ADDENDUM NO. 1

PROJECT NAME: NE Soccer & Tennis Complex- General Construction
UNL PROJECT NUMBER: C909P101/ 10186
BID INVITATION NUMBER: 2339-14-7200

CONSULTANT: RDG Planning & Design
ADDRESS: 301 Grand Avenue
Des Moines, IA 50309

DATE OF ISSUANCE: March 27, 2014
DATE OF BID OPENING: Tuesday, April 8, 2014
3:00 PM CT

FOUNDATION PLAN - INDOOR TENNIS/SUPPORT - AREA A

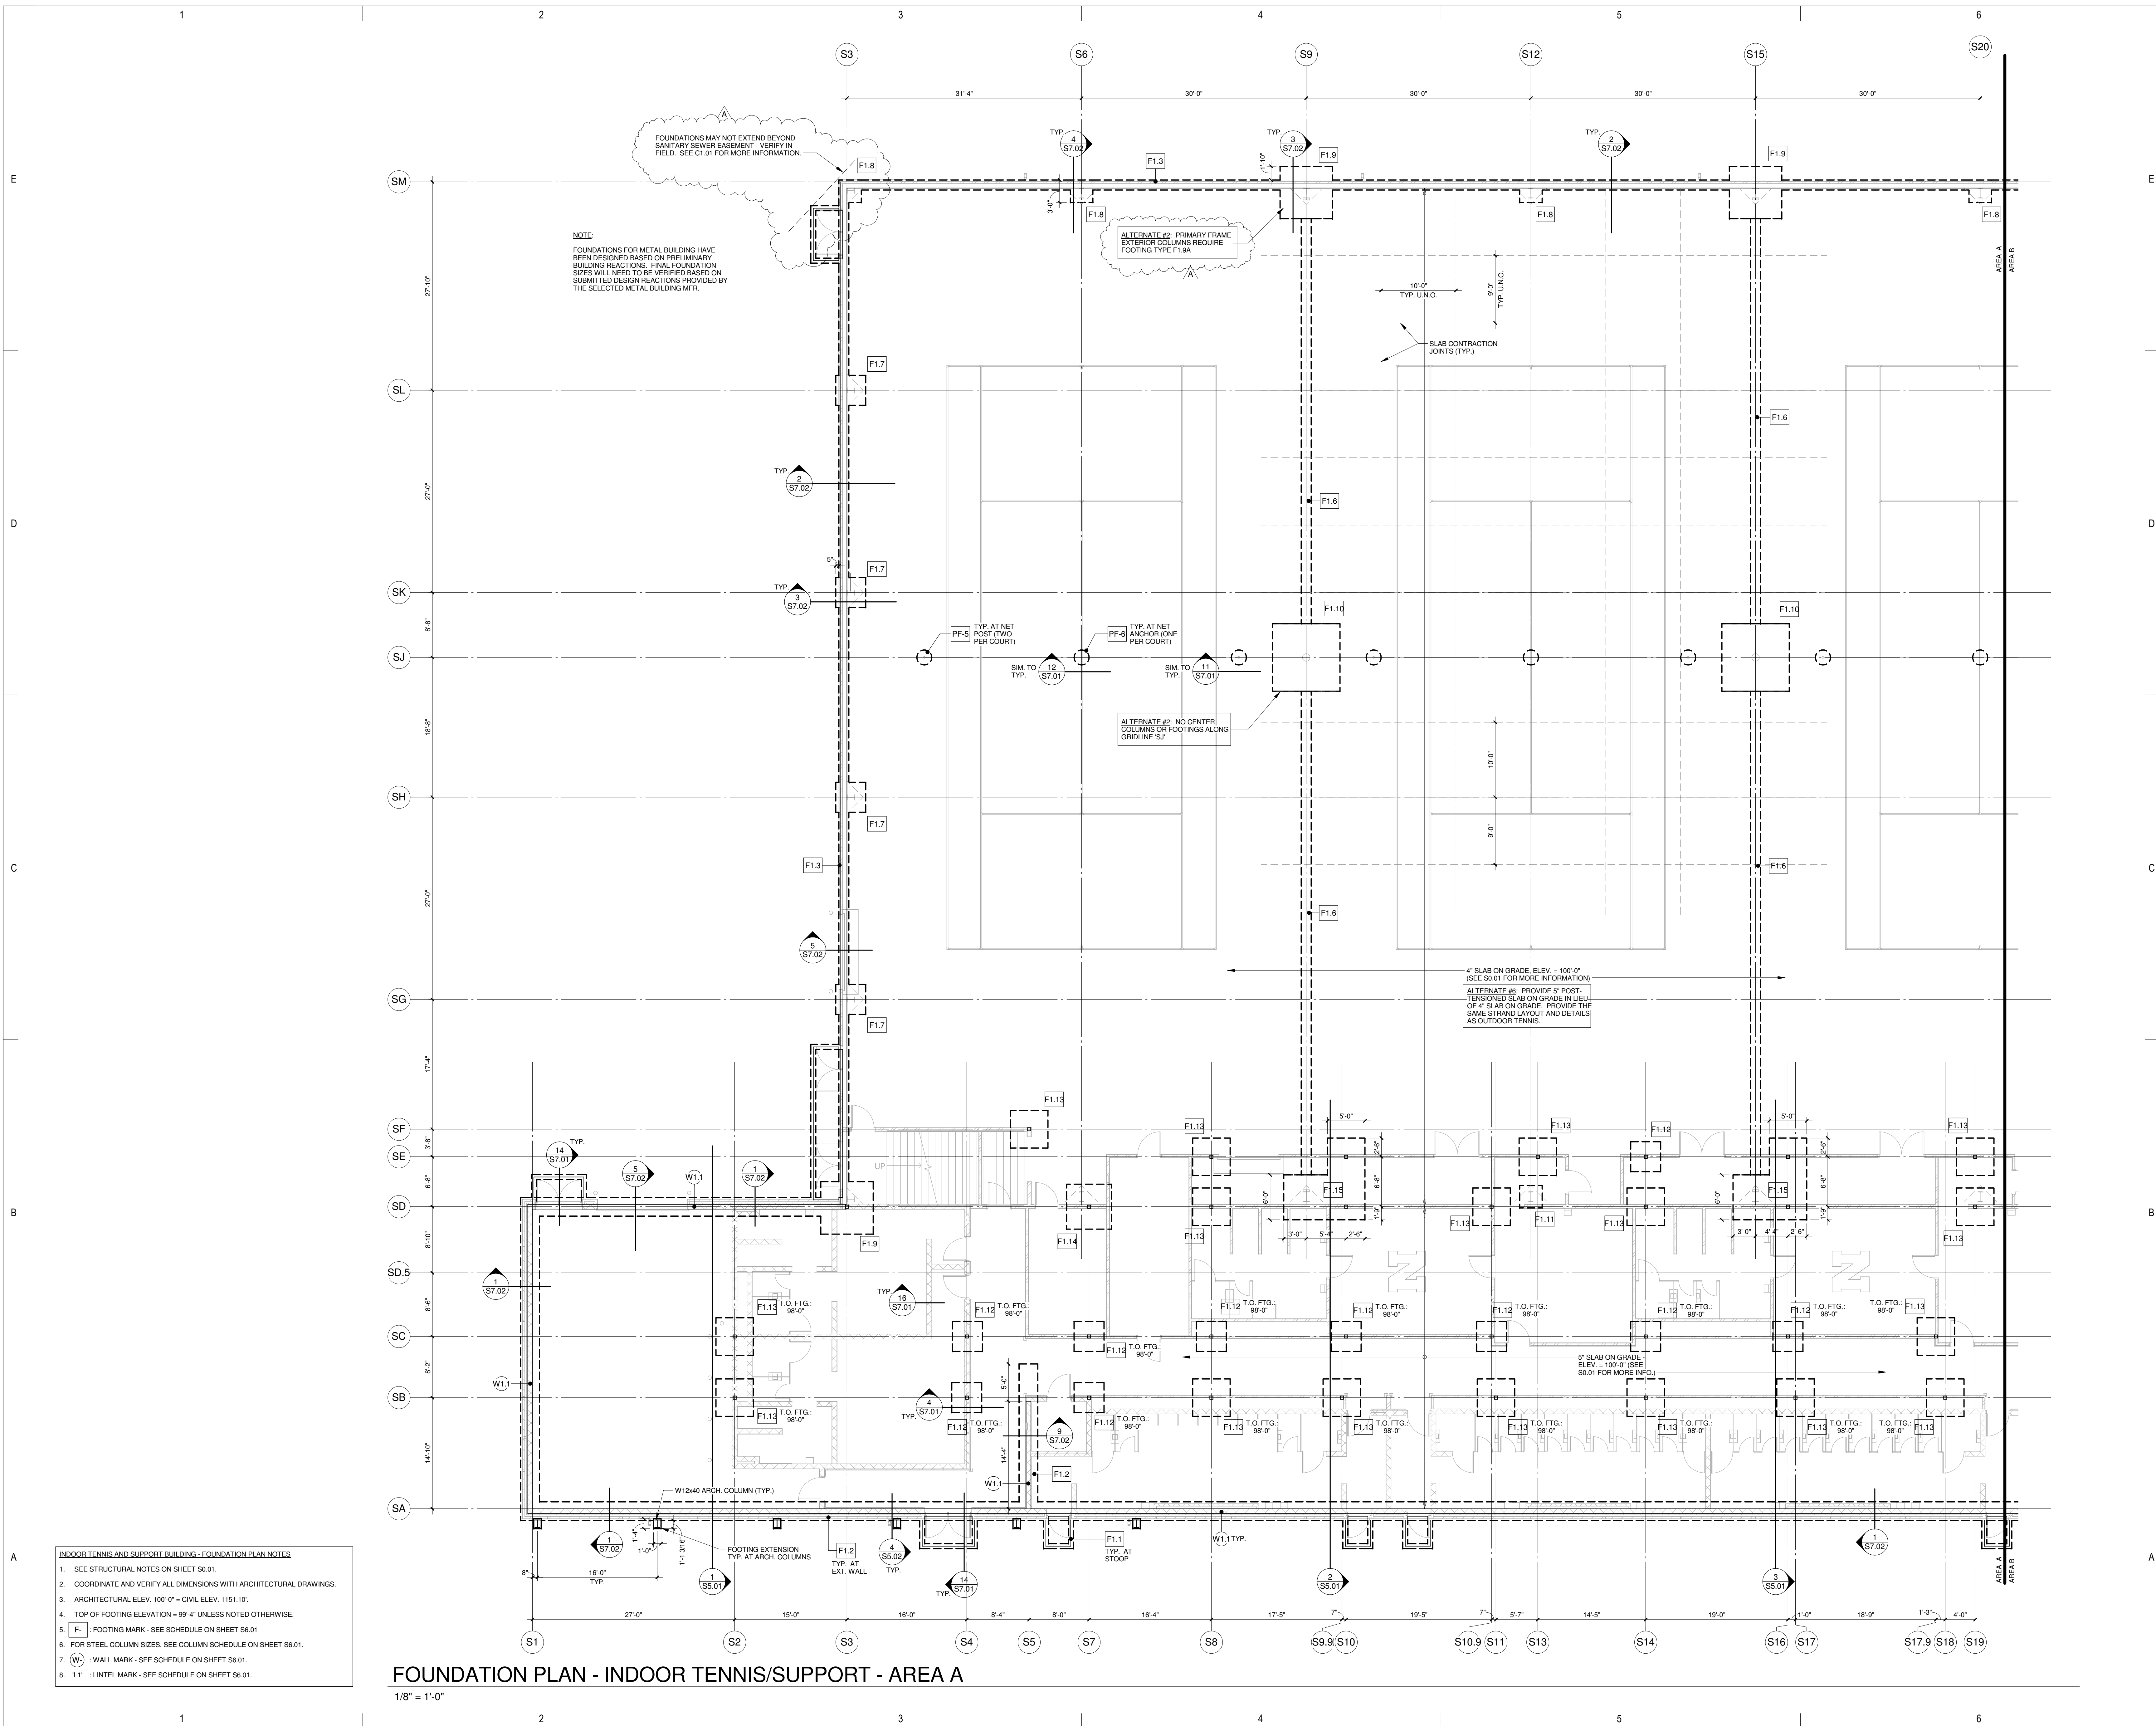
- 1GD-3** DRAWING S1.11A – Foundation Plan – Indoor Tennis/Support – Area A: Revise per attached Drawing S1.11A. (Added notes describing coordination at sewer easement located at the Northwest corner of Indoor Tennis as well as clarifications to Alternate #2).

**SECOND FLOOR
 PLAN - INDOOR
 TENNIS/SUPPORT
 - AREA B**

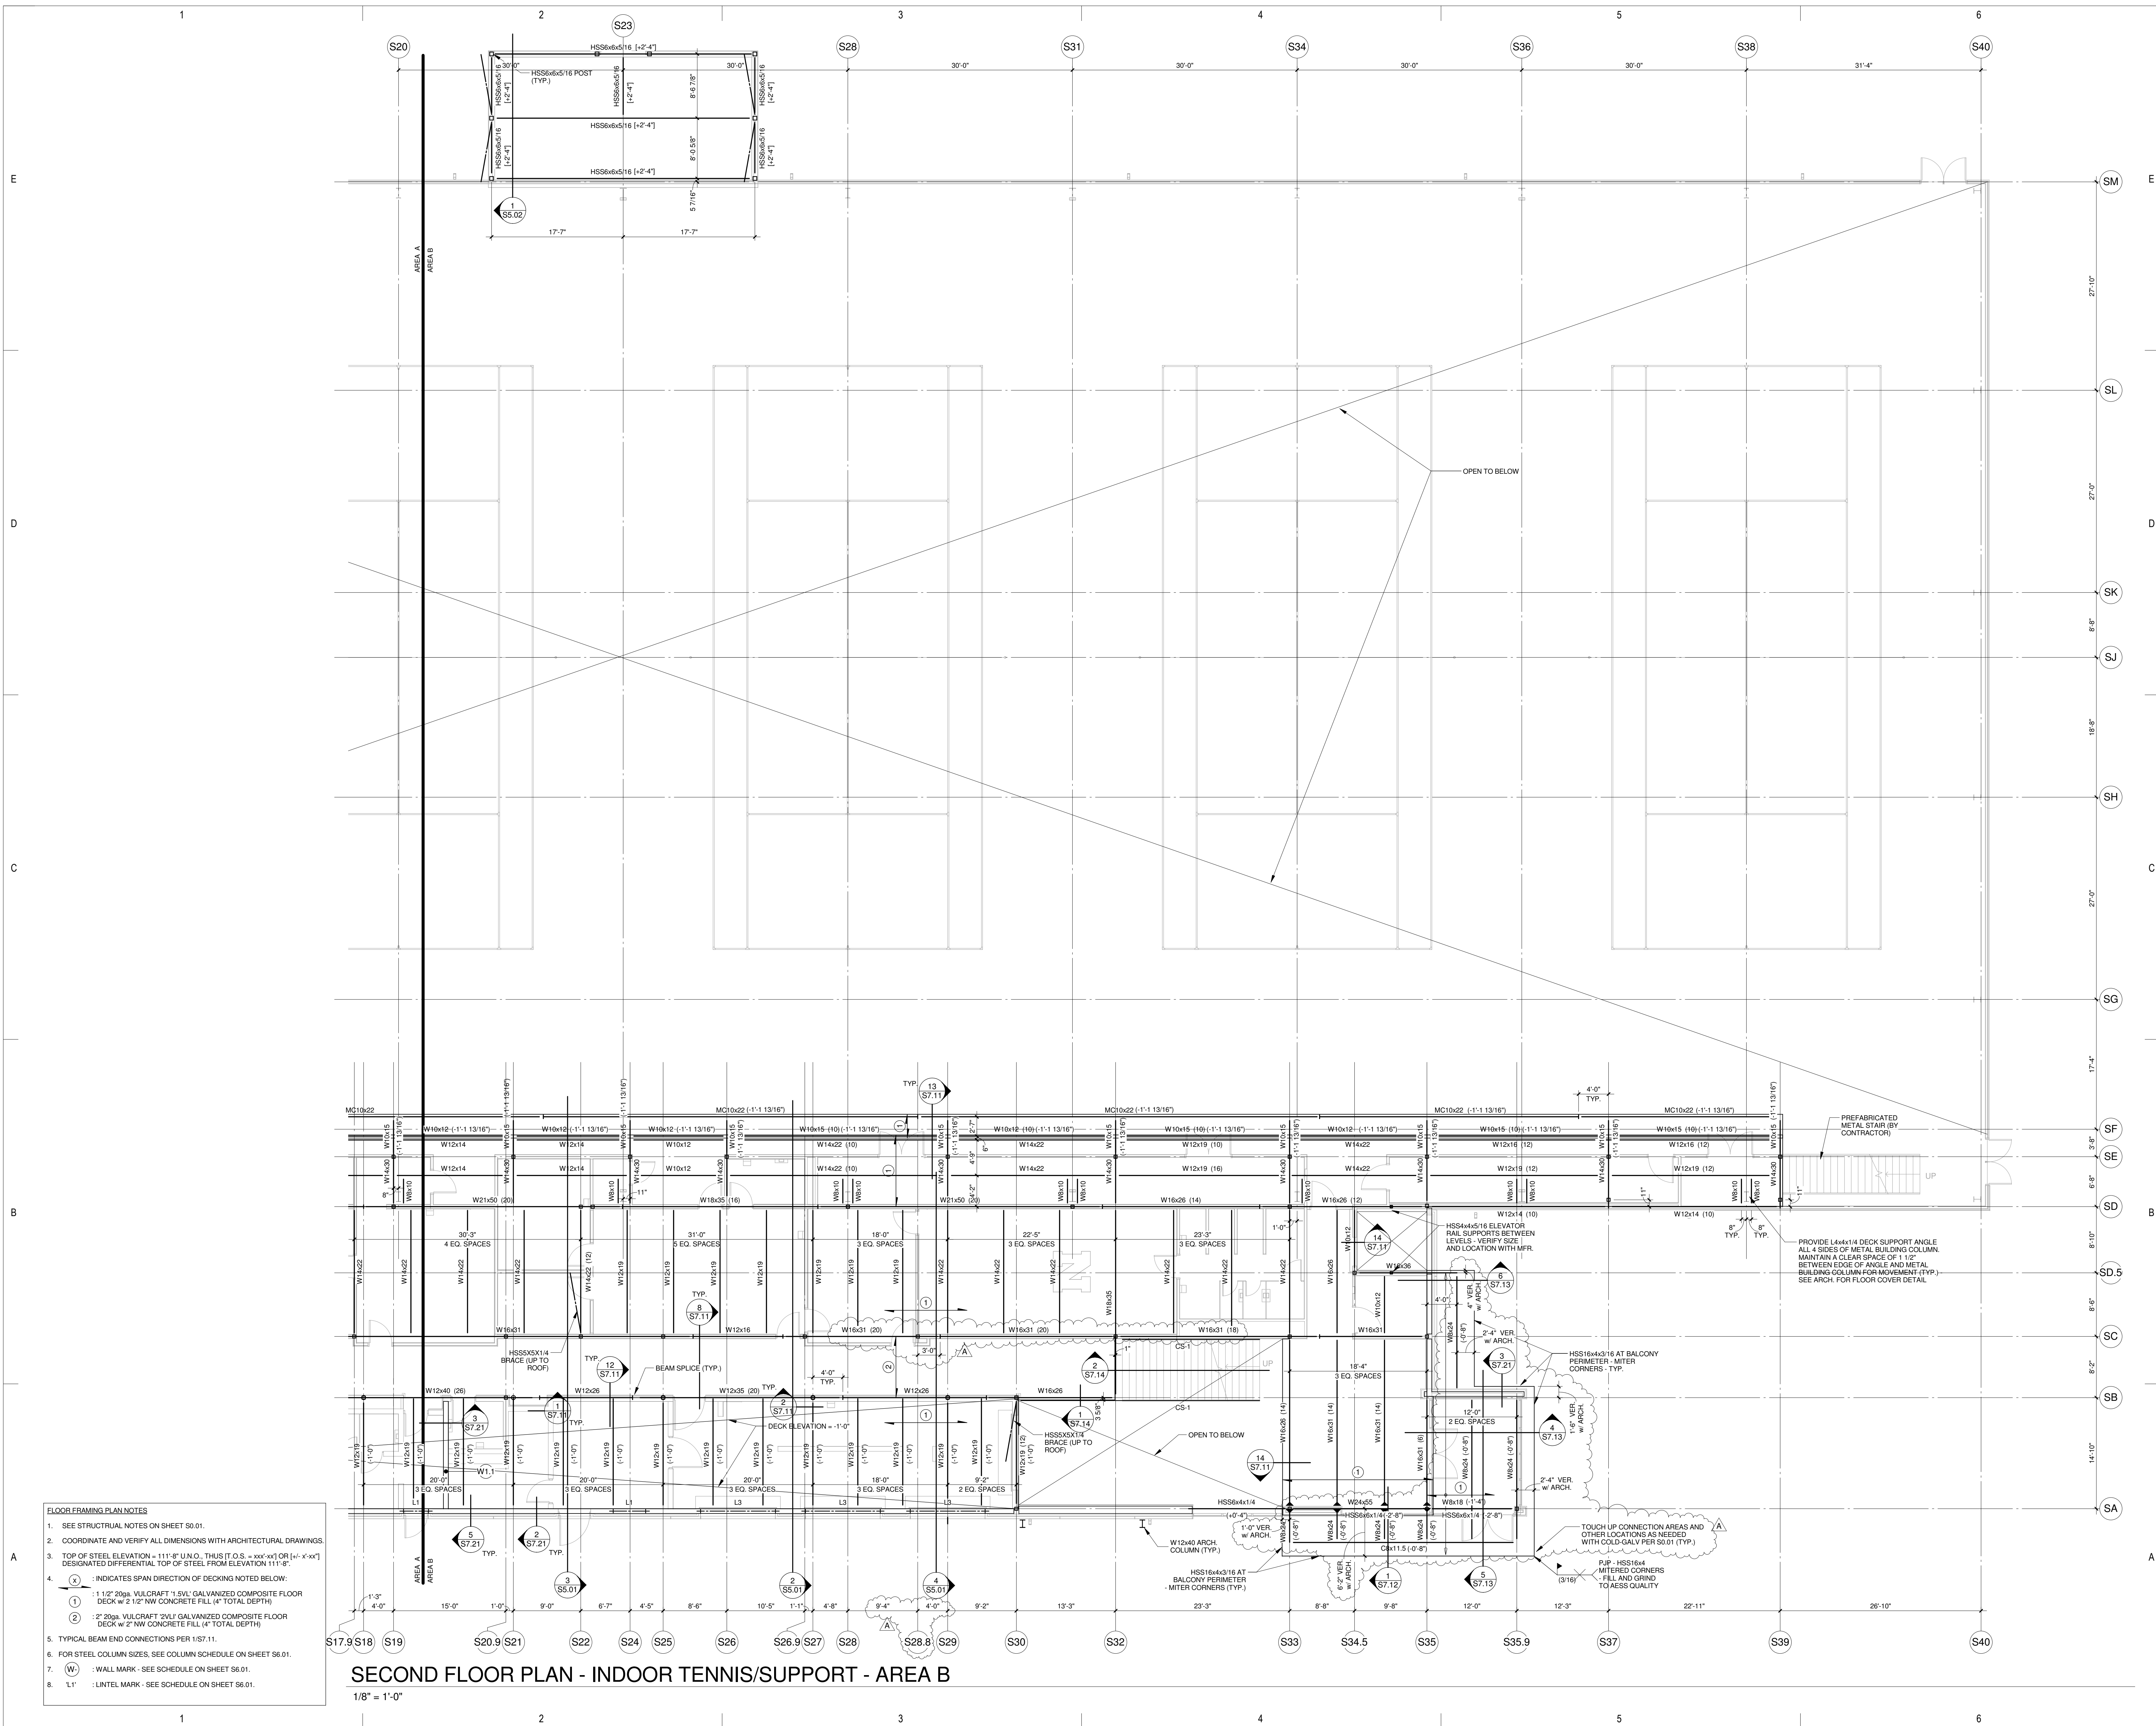
- A. Modifies final sentence of the note North of gridline SF, between gridlines S9 and S12 to read: “See arch for floor cover detail”.
- 1GD-6** DRAWING S1.12B – Second Floor Plan – Indoor Tennis/Support – Area B: Revise per attached Drawing S1.12B. (Moves column previously located at SC/S29 to SC/S28.8 (new gridline) and modifies adjacent beam sizes. Modifies deck edge at Support Building SW patio.)
